HOPE CREEK GENERATING STATION  
DOCKET NO. 50-354  
FSAR COMMITMENT STATUS THROUGH AUGUST 1984

ATTACHMENT I  
HOPE CREEK GENERATING STATION  
FSAR COMMITMENT STATUS THROUGH AUGUST 1984

QUESTION 220.21 (SECTION 3.7.2)

**FIGURE 220.21-7**

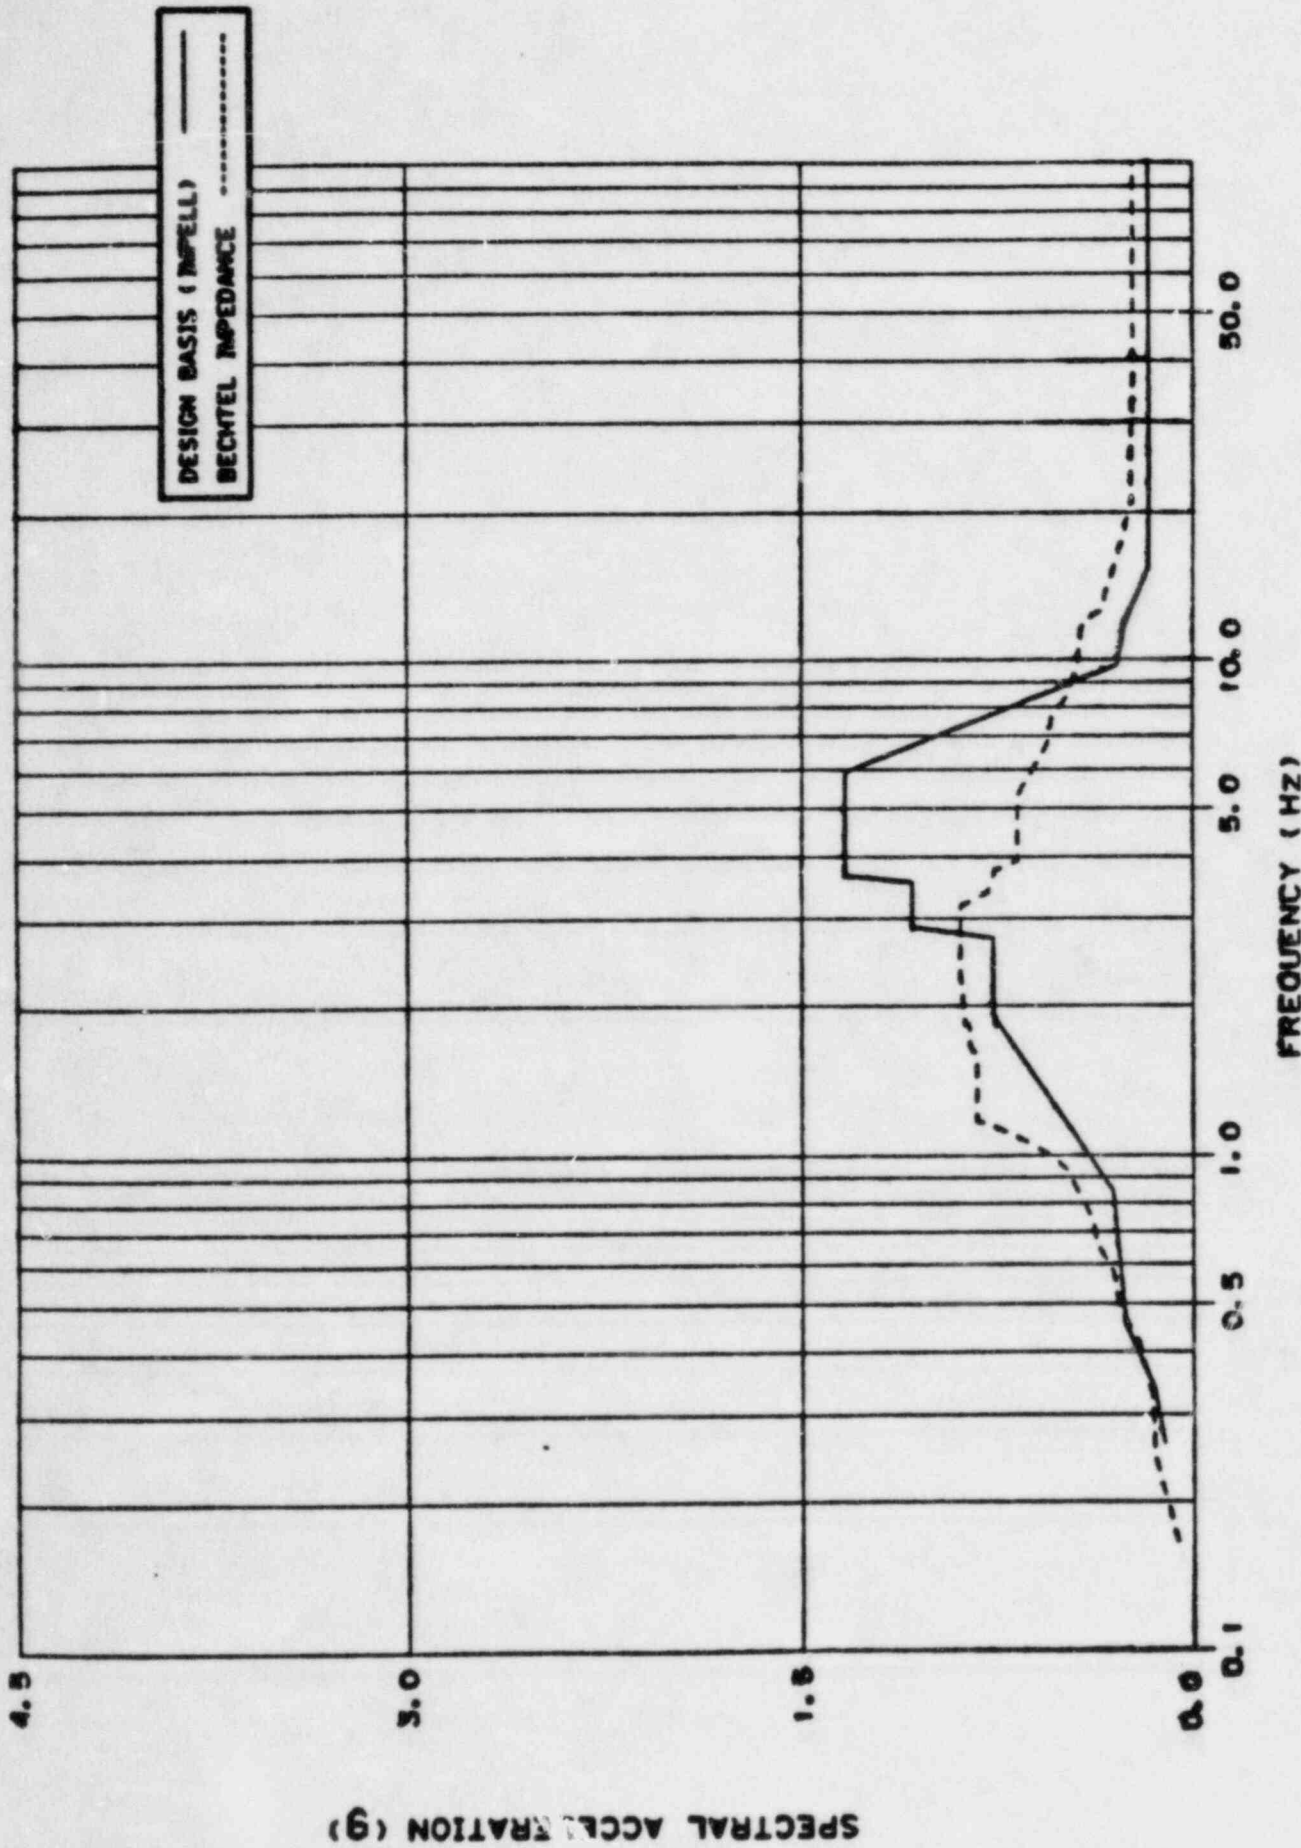
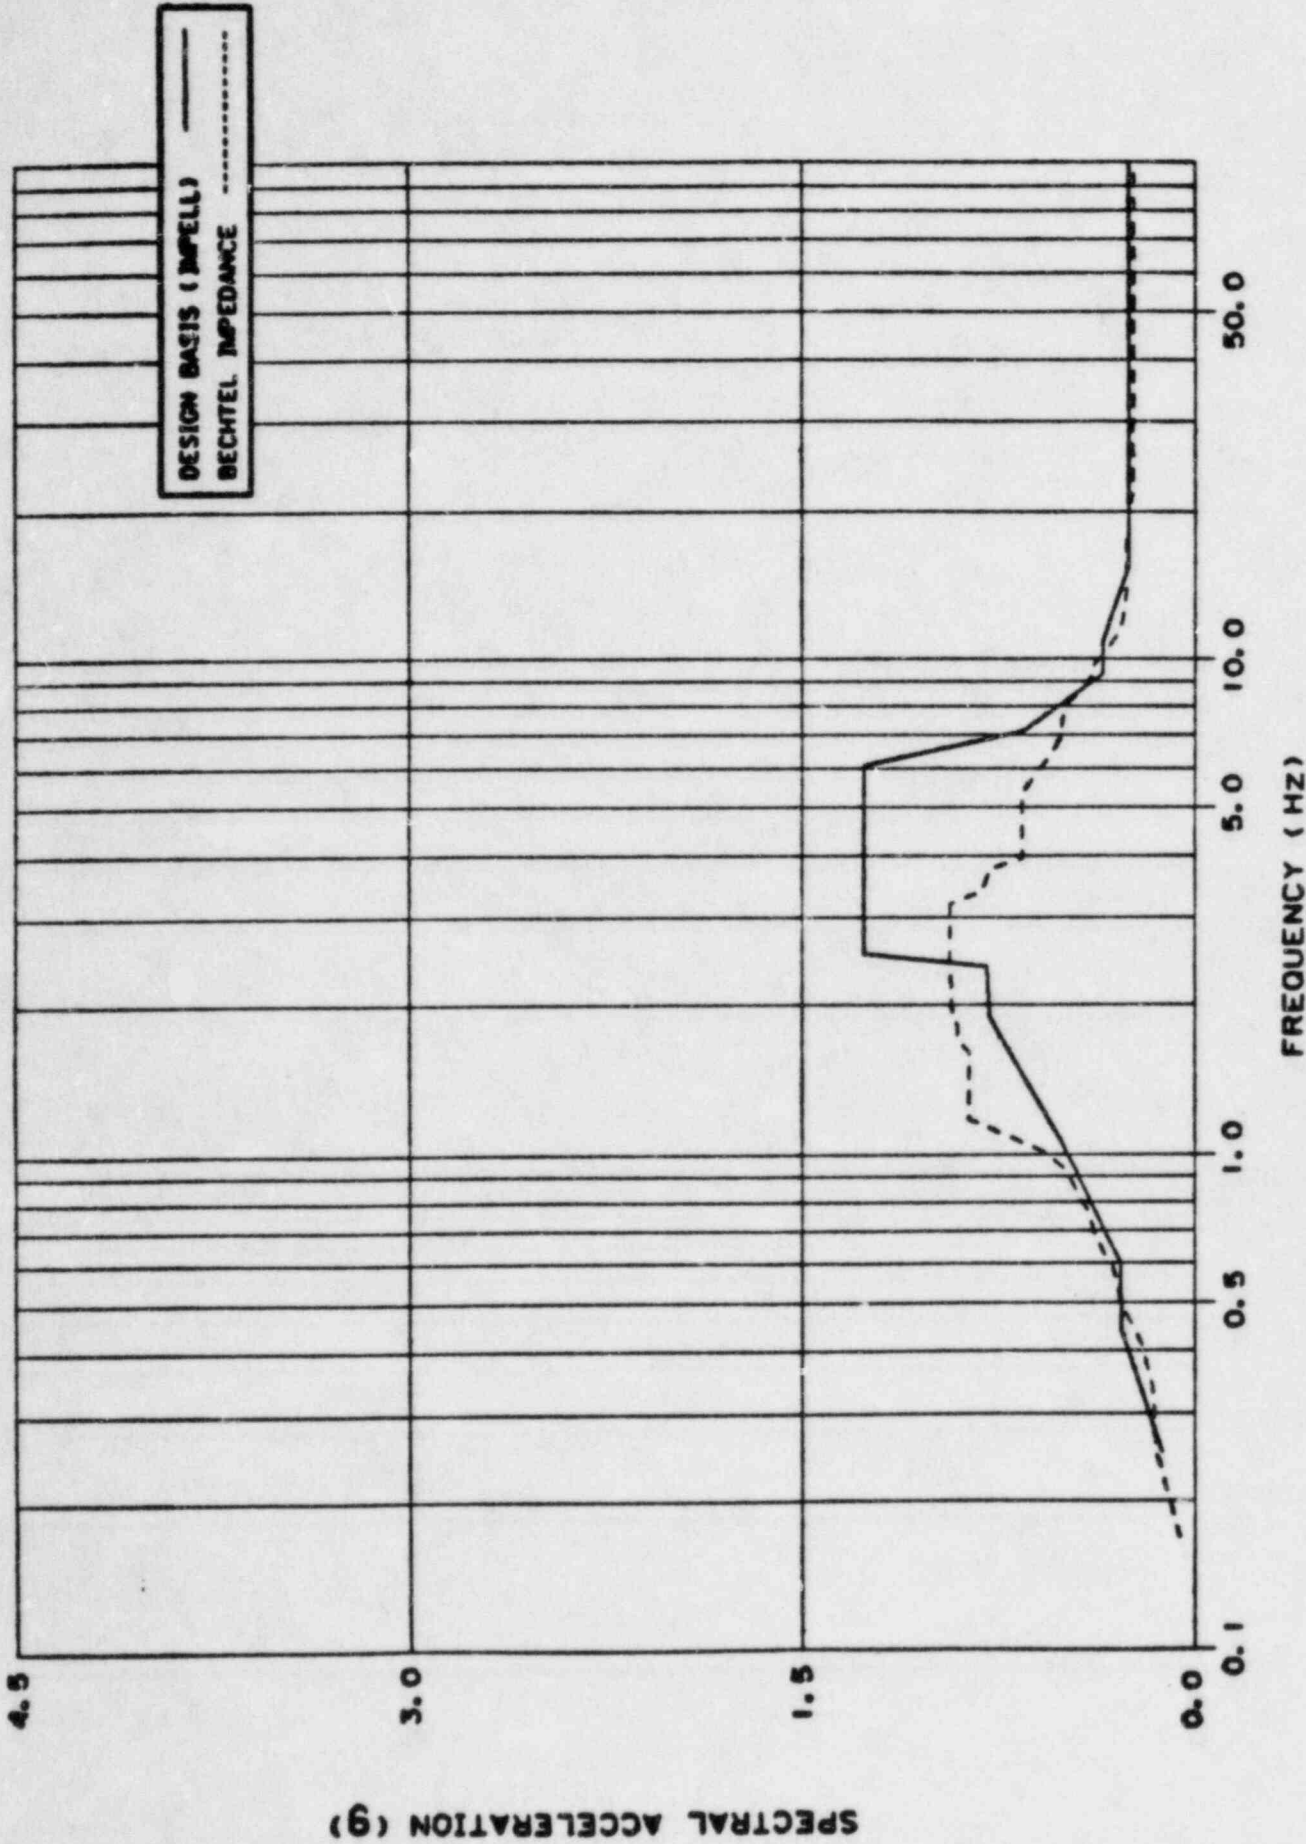
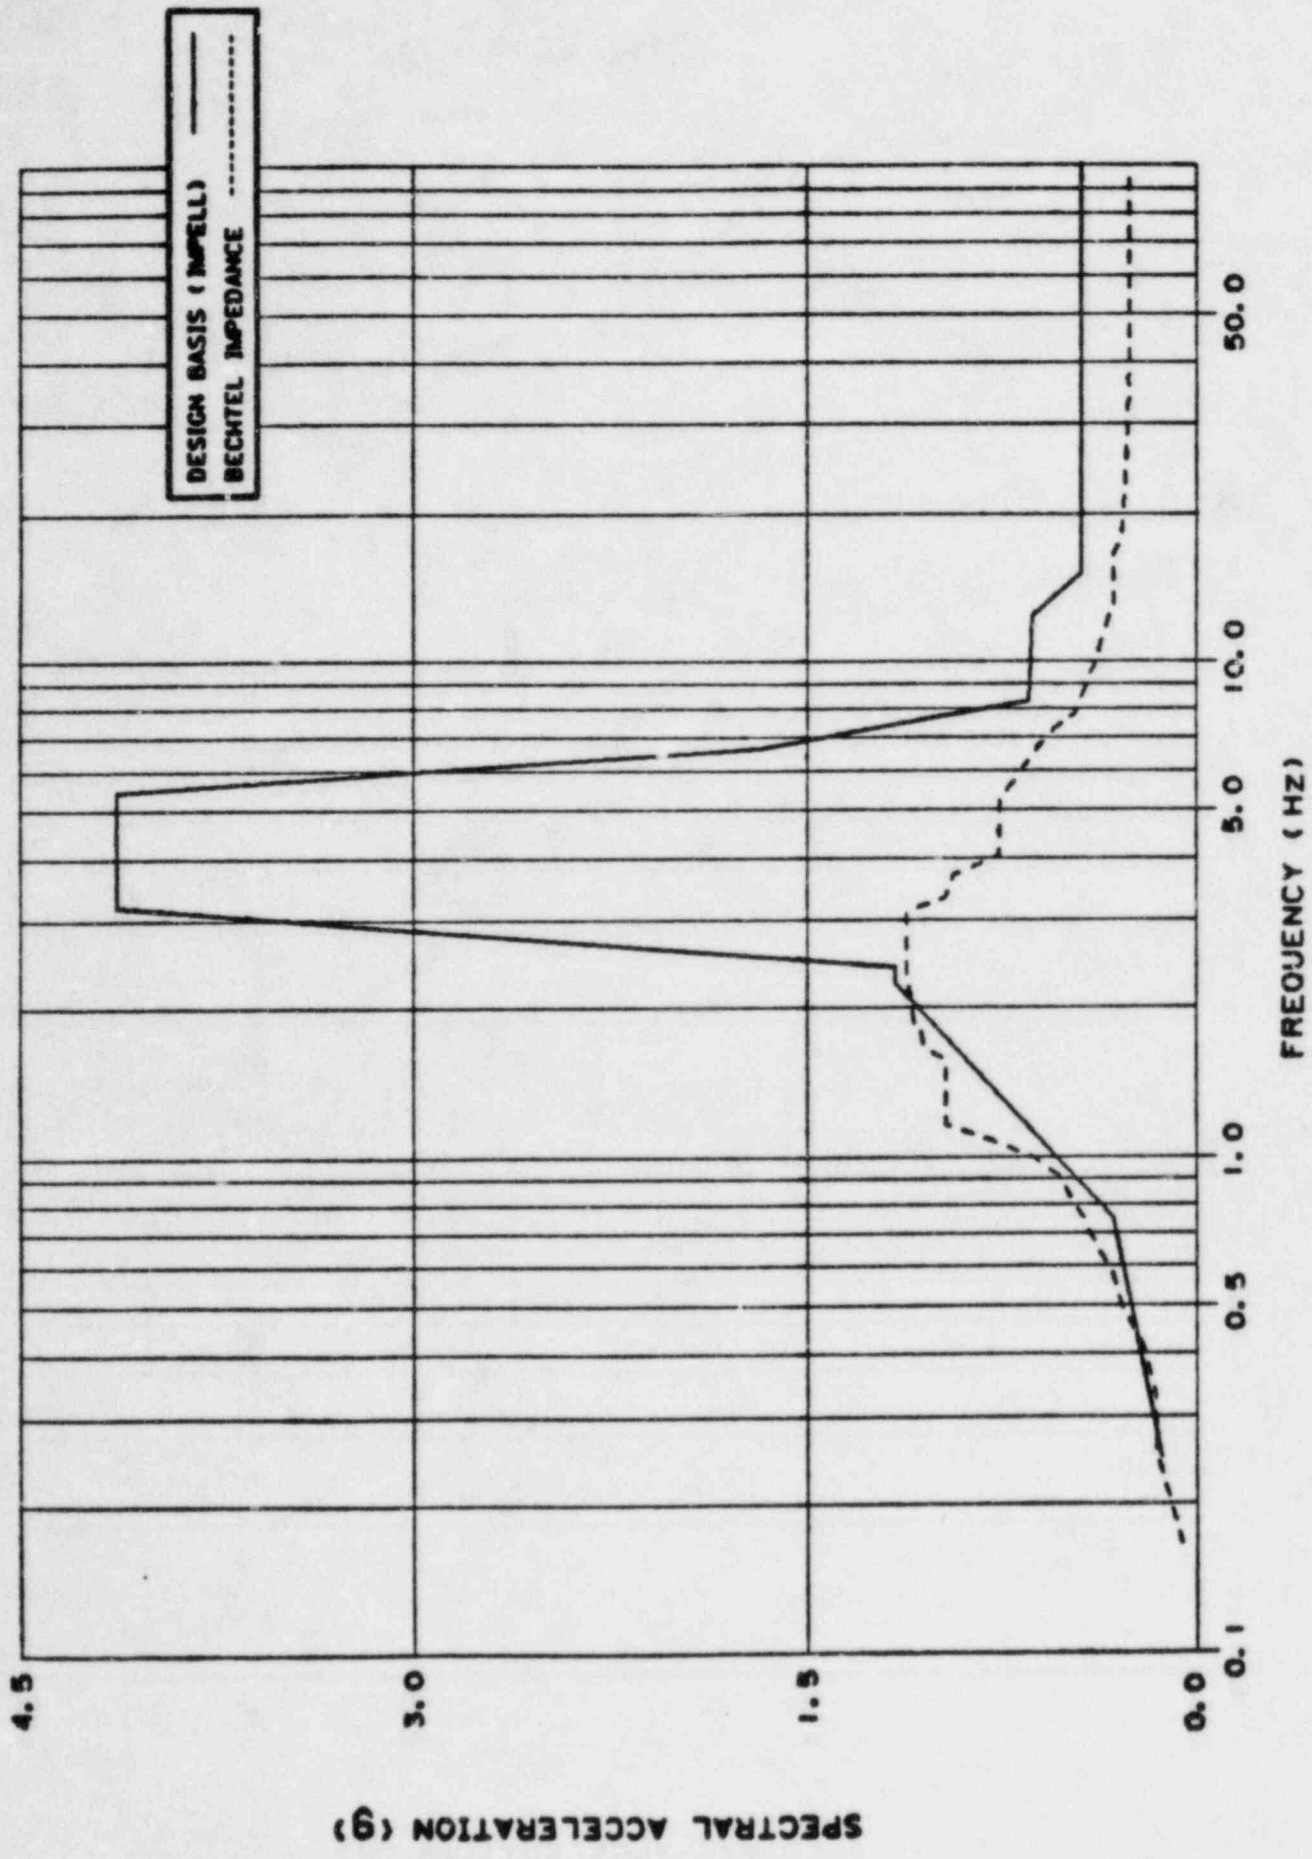
The Hope Creek soil-structure interaction analysis is performed by applying a specified earthquake input motion at the base of the finite-element model. The base level input motion is generated through a deconvolution analysis. The applicable SRP criteria for soil-structure interaction analysis require that both the half-space and finite-element approaches should be considered. (For details refer to SRP 3.7.2-11.4). Public Service should perform necessary analyses to demonstrate conformance to the criteria.

Figures 220.21-1 through 220.21-54 show a comparison of the 2 percent damping response spectra obtained from the design basis finite element and the impedance analyses for the reactor building, auxiliary building and the service water intake structure (SWIS).

¶ For the reactor and auxiliary buildings, the peak spectral accelerations obtained from the impedance analysis are generally lower than those obtained from the design basis analysis. However, the impedance analysis response spectra are not completely enveloped by those obtained from the design basis analysis, especially in the frequency range from 1.0 to 3.5 Hz. Also, there are some local exceedances in the higher frequency range, as shown in Figures 220.21-1 through 220.21-36. ¶ For the SWIS (Figures 220.21-37 through 220.21-54), the impedance analysis response spectra are generally enveloped by those obtained from the design basis analysis at elevation 114.0 feet. For other elevations, the impedance analysis spectral accelerations exceed the design basis spectral accelerations in some frequency ranges. These ranges vary approximately between 1.5 and 10.0 Hz.

forces and moments obtained from the impedance analysis exceeded the design basis values at various locations within these buildings. The auxiliary building seismic shear forces and moments obtained from the impedance analysis are less than the design basis shears and moments.

Since the impedance analysis results are not completely enveloped by the design basis finite element analysis results, sampling studies are conducted to confirm the adequacy of the plant design. These sampling studies include an evaluation of the following items:

In all cases, the items reviewed during these sampling studies can accommodate the loads resulting from the impedance analysis. Therefore, the impedance analysis results have no impact on the plant design.
